# RAILROAD COMMISSION OF TEXAS

### AMENDED PROPOSAL FOR DECISION

**OIL AND GAS DOCKET NO. 02-0289582**

**THE APPLICATION OF PYOTE RECLAMATION SYSTEMS, LLC, PURSUANT TO  
STATEWIDE RULE 8 FOR A PERMIT TO MAINTAIN AND OPERATE A  
COMMERCIAL STATIONARY TREATMENT AND DISPOSAL FACILITY, HOHN ROAD  
FACILITY, DEWITT COUNTY, TEXAS**

<b>PYOTE RECLAMATION SYSTEMS, LLC</b> HOHN ROAD FACILITY		
Figure 1		
<b>SITE PLAN</b>		
PROJECT 1925	BY: MKB	REVISIONS
DATE: SEP. 2015	CHECKED: PJB	
<b>PASTOR, BEHLING &amp; WHEELER, LLC</b> CONSULTING ENGINEERS AND SCIENTISTS

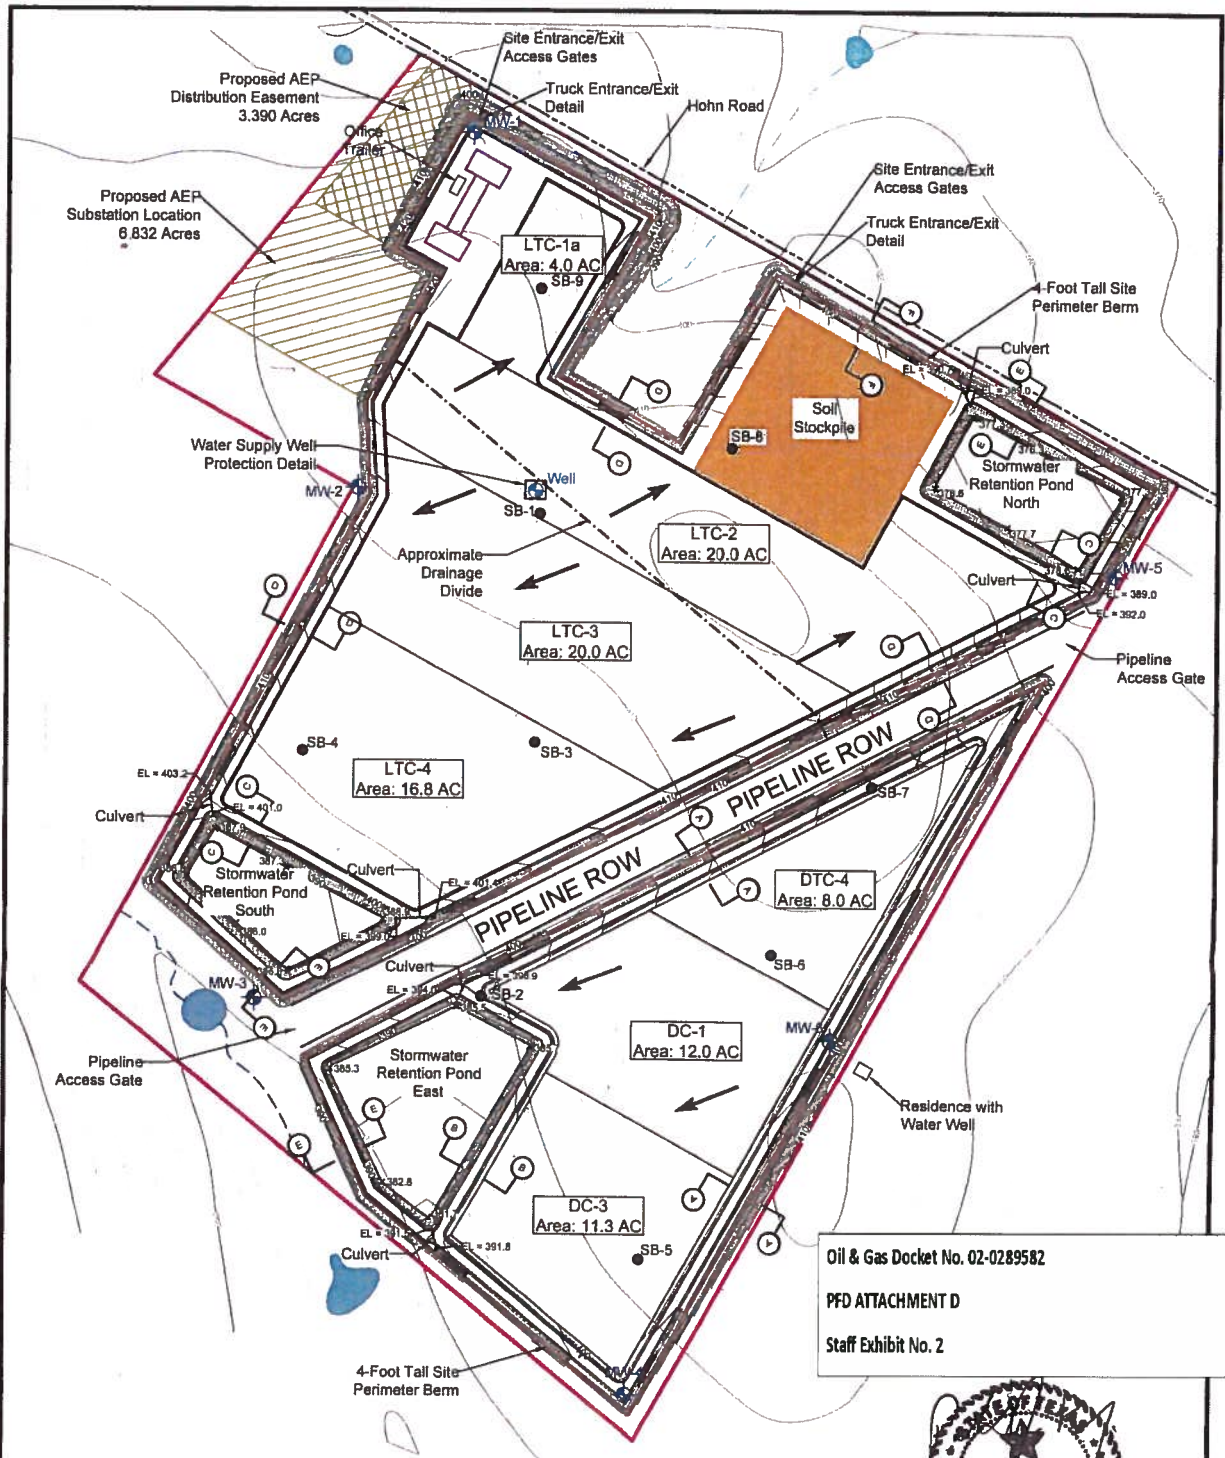
CAP expressed concern that storm water may pool within the perimeter dike system and not drain to the storm water retention ponds. Specifically, Mr. von Dran, CAP's engineering witness, identified the area near LTC-1A as susceptible to this concern.<sup>12</sup>

CAP raised several concerns regarding the engineering design and construction materials of specific aspects of the revised site plan (Attachment D), especially considering the increased design stress from a 50-year/24-hour storm event. In particular, Mr. Von Dran identified the following concerns:

- There is no evidence in the record to suggest that on-site soils possess the necessary engineering characteristics to ensure their suitability for use as construction materials in unit containment and perimeter berms<sup>14</sup>;
- The revised site plan indicates the perimeter berm will be located atop a 20-foot earthen embankment adjacent to LTC-1a and Hohn Road and an unnamed ephemeral stream (see Attachment D), and such an embankment would be highly susceptible to erosion<sup>15</sup>; and

The Examiners do not read the revised site plan (Attachment D) in the same way. The site plan does illustrate drainage of non-contact storm water from the LTC-1A area along the perimeter dike and into Storm Water Retention Pond North. The path is somewhat tortuous, but the site plan grading indicates drainage into the pond. There may be some confusion between contact and non-contact storm water in this regard. Contact storm water will be contained by the unit berm within LTC-1A itself, and Pyote will be required to dispose of the contact water in an authorized manner according to the proposed draft permit (provision X.C.).

The Examiners note that unit containment and perimeter berms required by the proposed draft permit are engineered structures designed and built to responsibly contain waste, contact water, or storm water, as appropriate. As engineered structures, the berms will be designed and maintained in a manner to prevent erosion. CAP's expert is correct that the available on-site soils have not been demonstrated to be suitable material for berm construction. Pyote's responsibility is to construct berms that meet the requirements of the permit as well as relevant guidance and professional practice, whether that requires making use of on-site soil or importing suitable material. The Examiners note the Commission's design standard for an earthen berm, according to the Surface Waste Management Manual, is for material that is capable of achieving a permeability of  $1 \times 10^{-7}$  centimeter per second or less when compacted. Further, the Manual states that during construction, successive lifts should not exceed nine inches in thickness, and the surface between lifts should be scarified to achieve a good seal. Pyote may attempt to use on-site soil, as is or amended, or it may import new material for use in engineered structures
